# 1990 Corvette: Service Bulletin: Information on Door Lock System Components and Replacement Components

**Subject:** INFORMATION ON DOOR LOCK SYSTEM COMPONENTS AND REPLACEMENT COMPONENTS

**Model and Year:** 1990 CORVETTE

**Bulletin Number:** 90-375-10 - (10/25/1990)

Figure 1

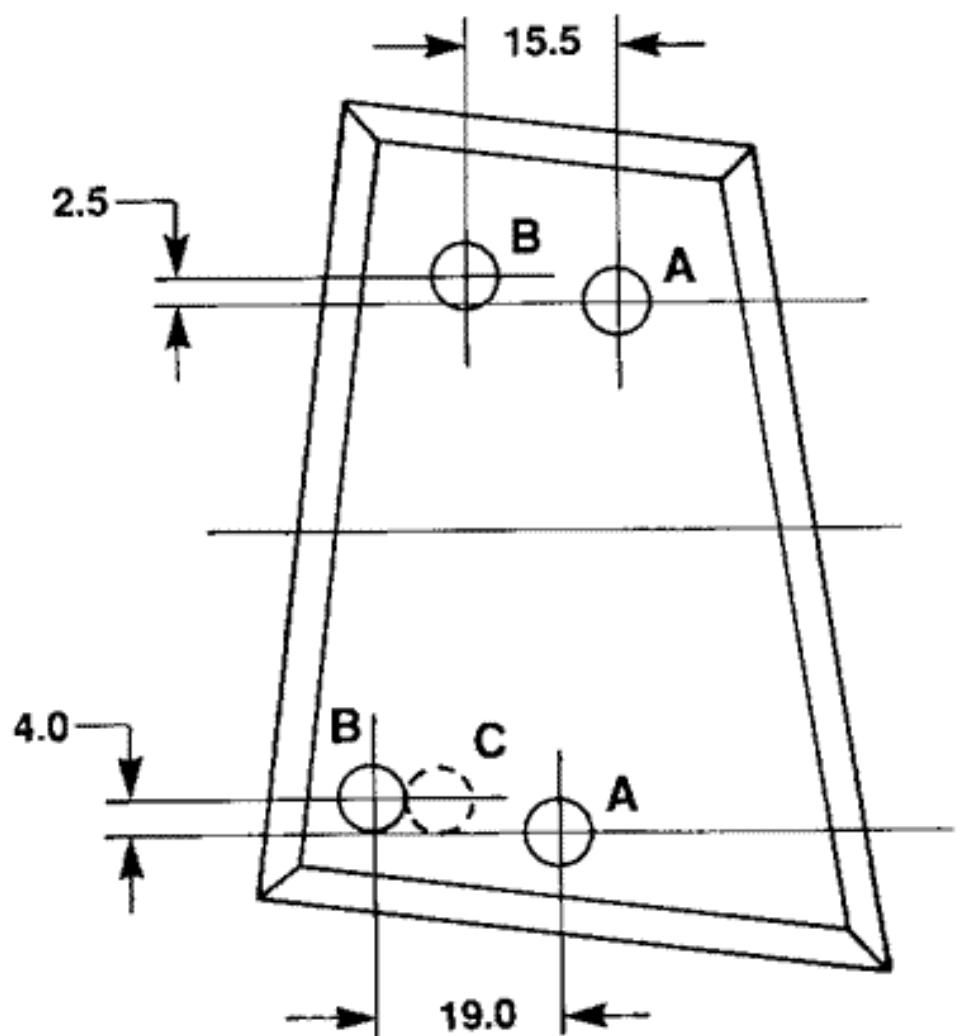
In addition to replacing the above components, it may be necessary to relocate the power door lock actuator on the door inner panel. Figure 1 will illustrate the hole patterns.

- If the actuator is located in the holes marked "A," it will not need to be relocated.

- If the actuator is located in the holes marked "B";
- remove the actuator by drilling out the attaching rivets.
- locate the new attaching holes ("A") using the dimensions on the illustration.
- attach the actuator in the new location using 1/4" X 1/2" peel type rivets.

**IMPORTANT: Hole "C" may or may not be present. Relocate holes from "B" locations only.**

HOLES A: NEW HOLE POSITION

HOLES B: OLD HOLE POSITION

HOLE C: MAY OR MAY NOT BE PRESENT
